No.	Date	Description
1	2025-09-19	Add No. 1
2	2025-09-30	Add No. 2

**WCFPD Station 3**  
**Wright City Fire Protection District**  
9 Highway WW  
Wright City, MO 63390

9/30/2025 3:21:17 PM

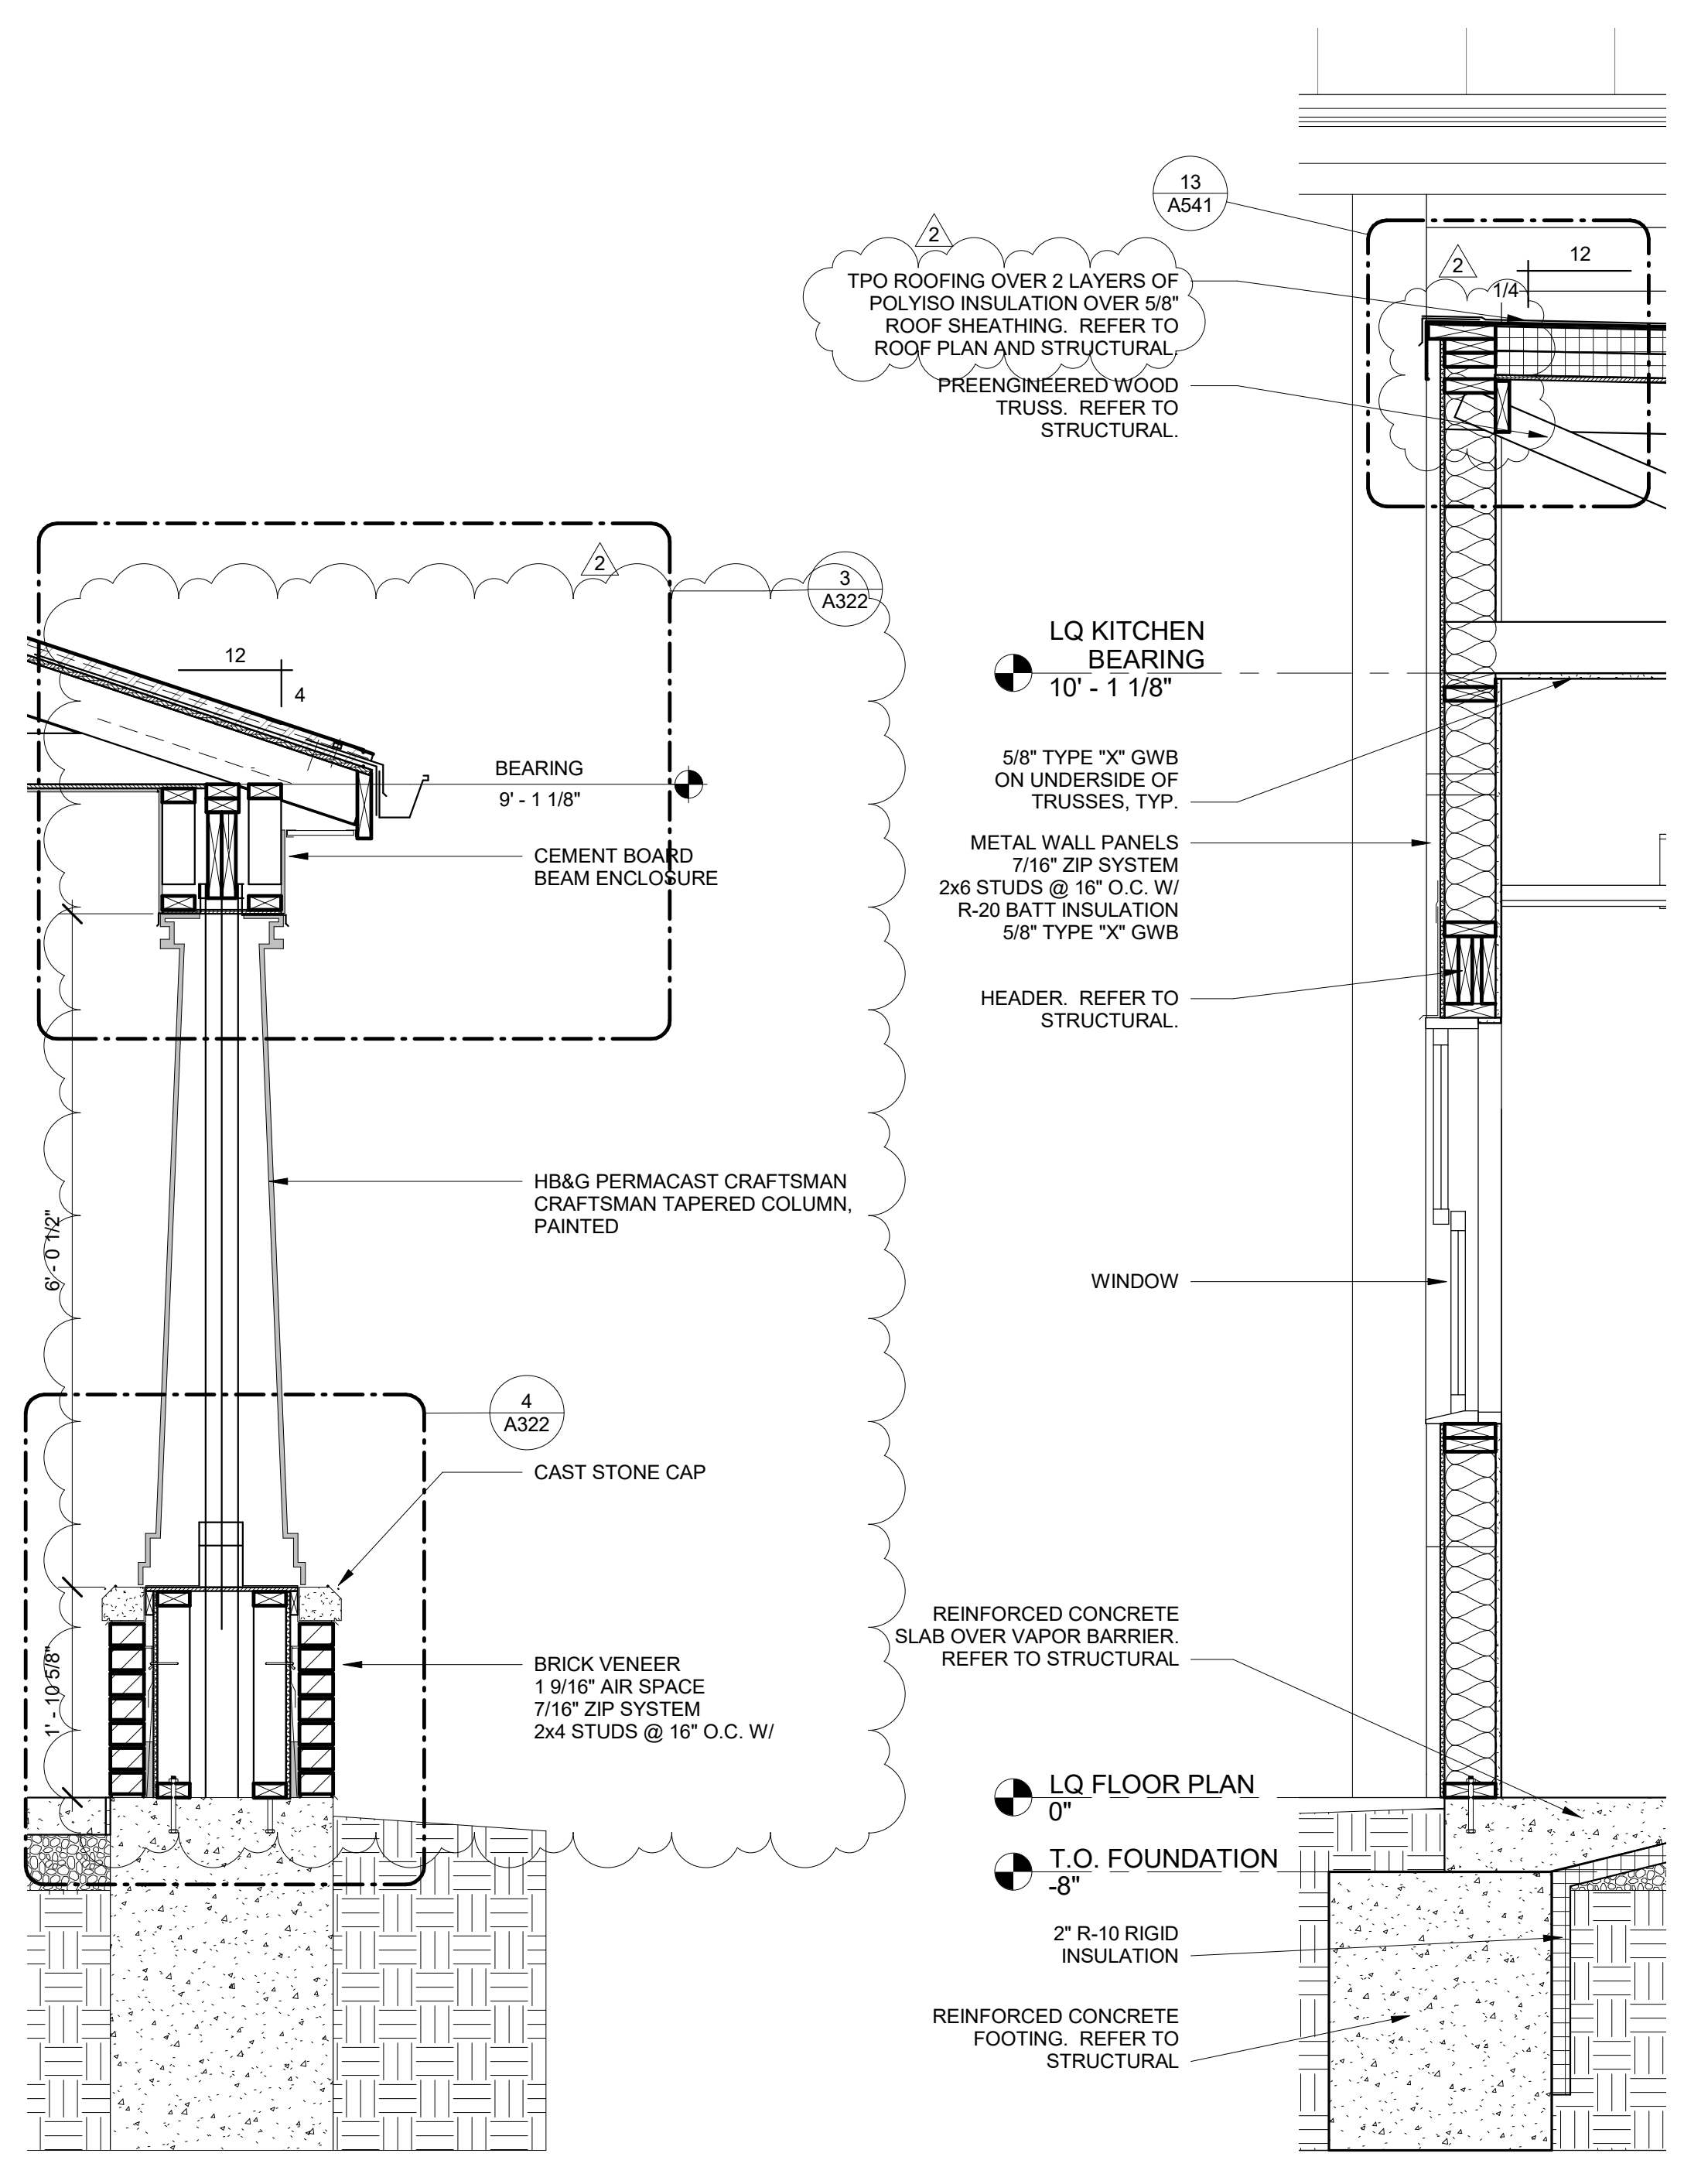
- 23) Sheet A321 – WALL SECTIONS
  - a. REVISE all wall sections.
  - b. ADD fireblocking note.
- 24) Sheet A322 – WALL SECTIONS
  - a. REVISE wall sections.

- b. ADD Wall Sections 5/A322 and 6/A322 for alternate brick veneer (at the North addition) and adhered thin brick (at the existing building and the South end of the new app bay).

- c. ADD fireblocking note.
- 25) Sheet A541 – SECTION DETAILS
  - a. REVISE details.
- 26) Sheet A601 – DOOR SCHEDULE AND PARTITION TYPES
  - a. REVISE Door 118A and add Door 201 in the Door Schedule.

**FOUNDATION PLAN**  
SCALE: 1/4" = 1'-0"  
PLAN NORTH

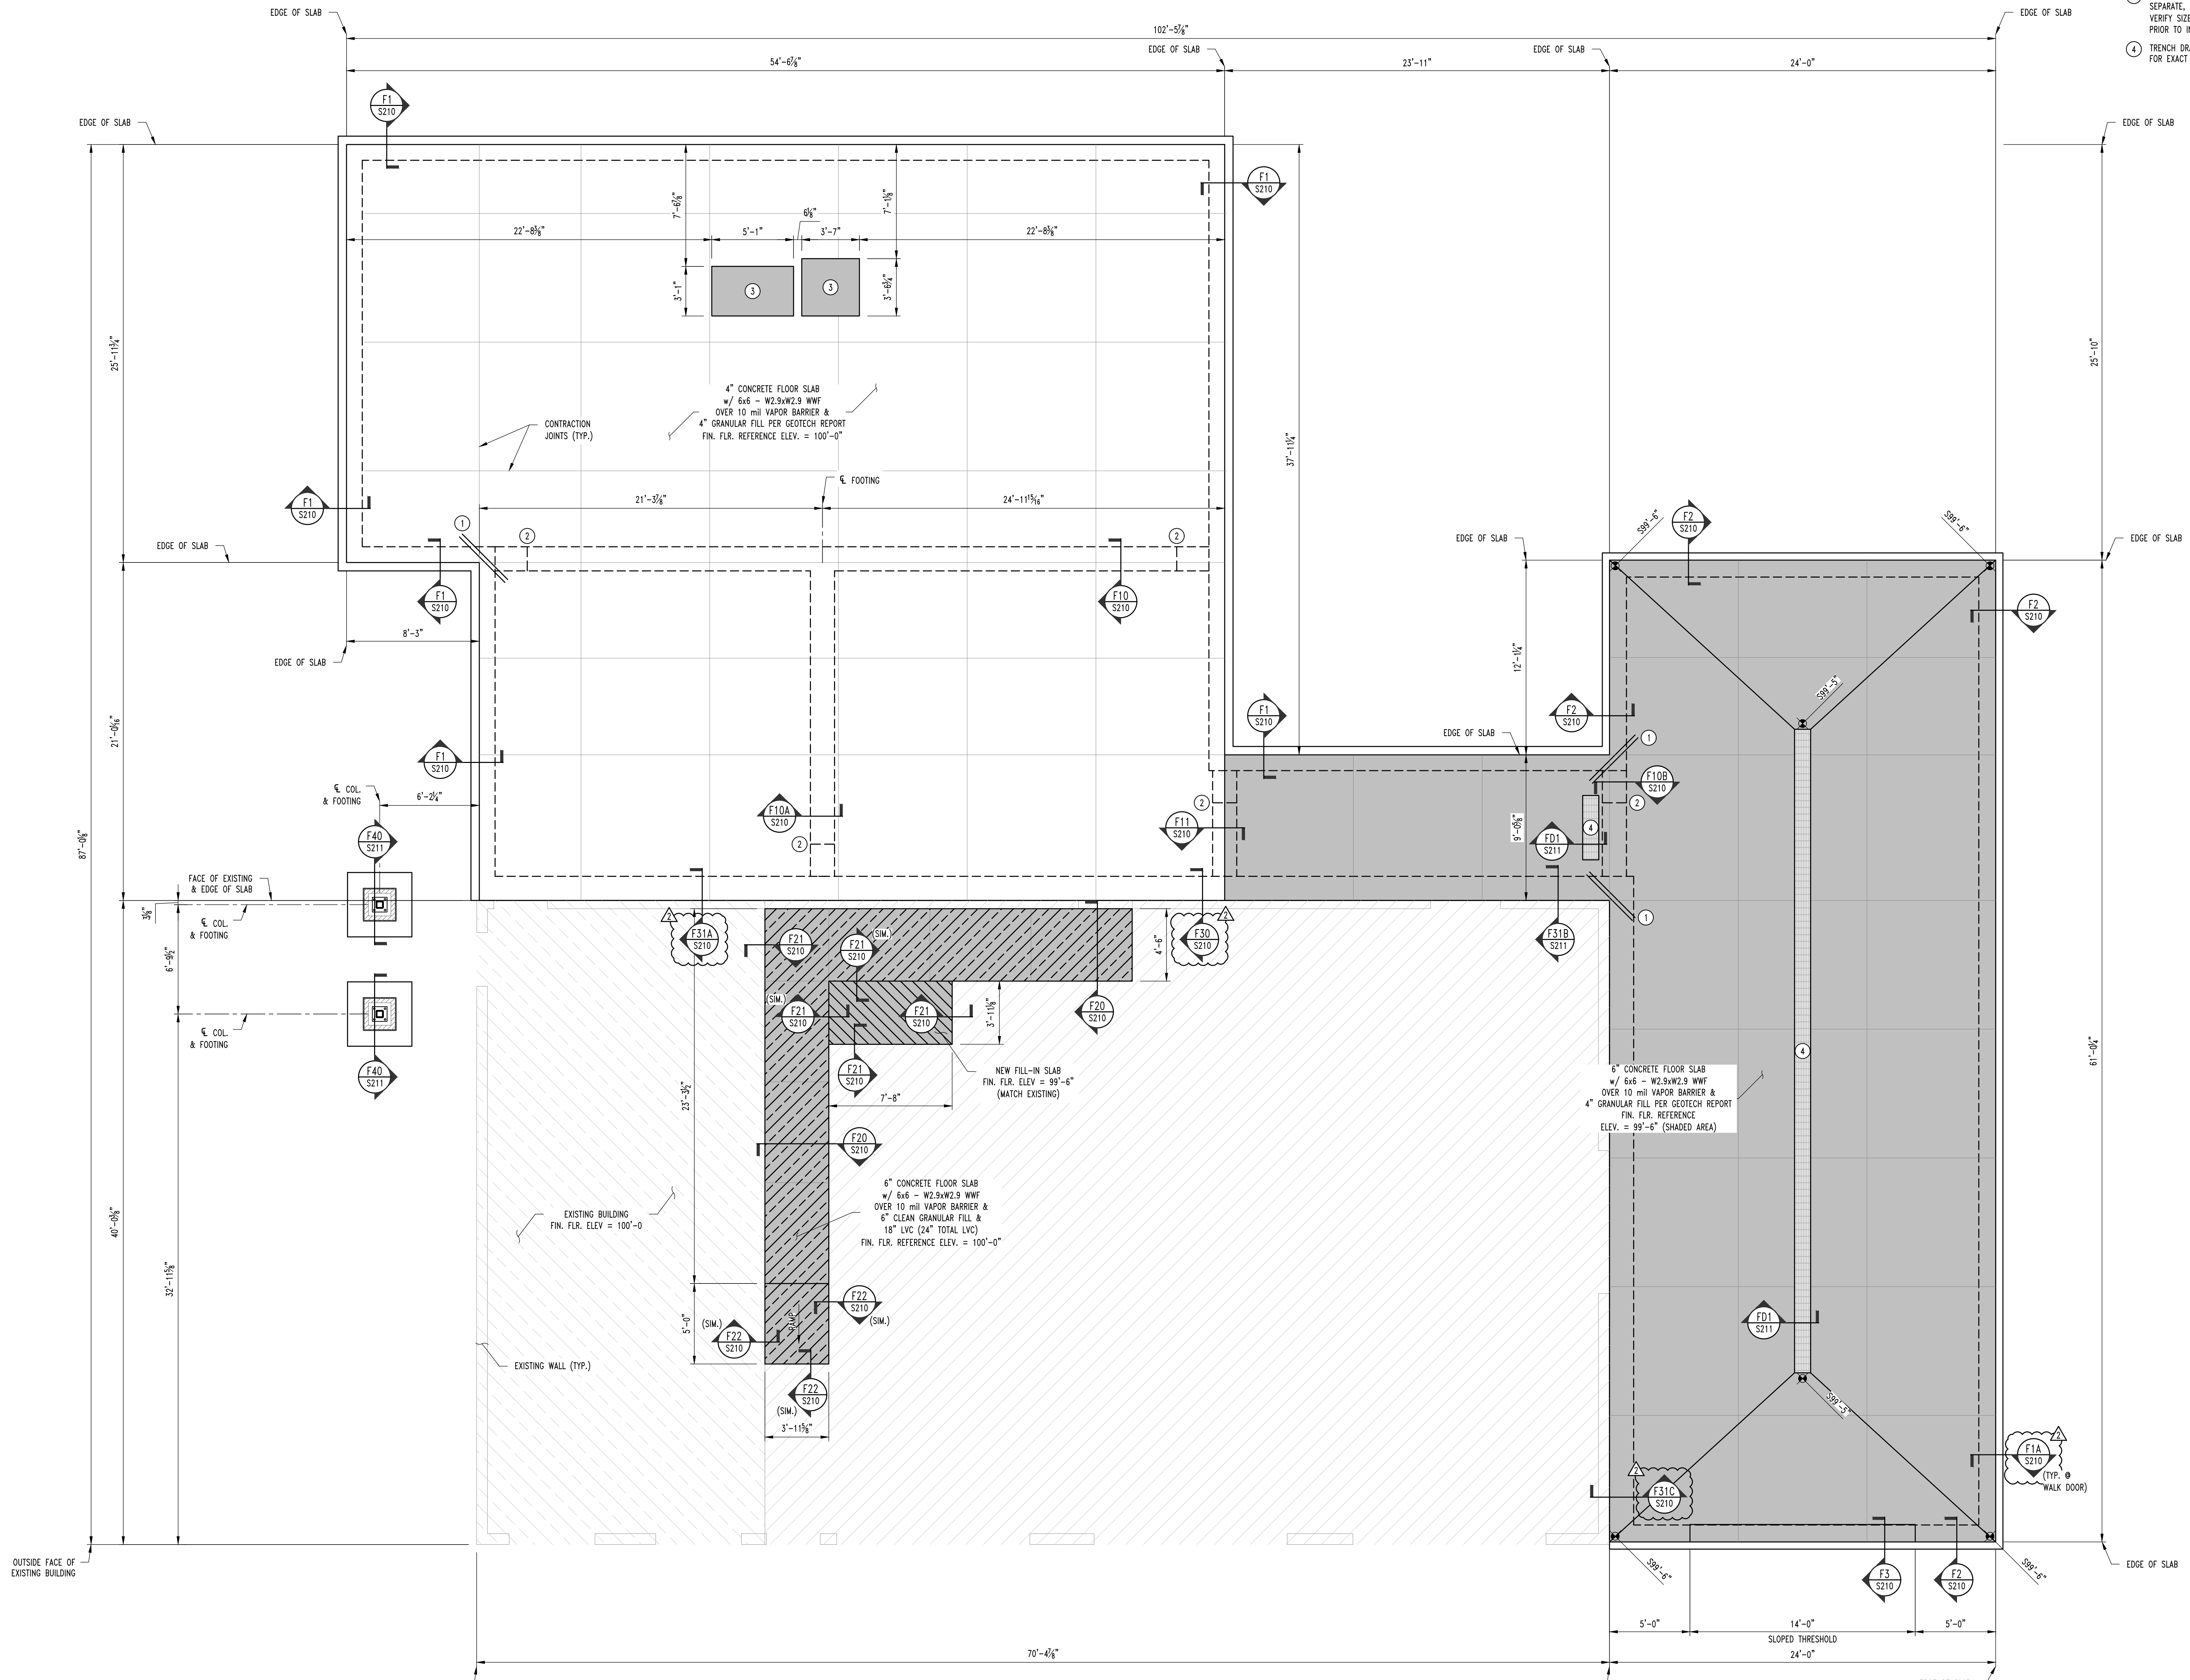
- b. ADD Keyed Note Schedule.
- 28) Sheet S200 – FOUNDATION PLAN
  - a. UPDATED sheet numbers on section cuts.
- 29) Sheet S210 – FOUNDATION DETAILS
  - a. ADD F1 Alt. detail for brick.
